## Detailed Road map modifications

[ Change Compatetisto call @ L.244

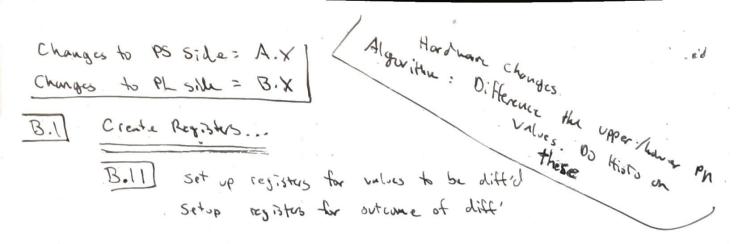
Befor-

(..., ..., data\_are\_h, ..., ...)

After

call

(..., ..., data\_difs\_arr\_in, ..., ...)
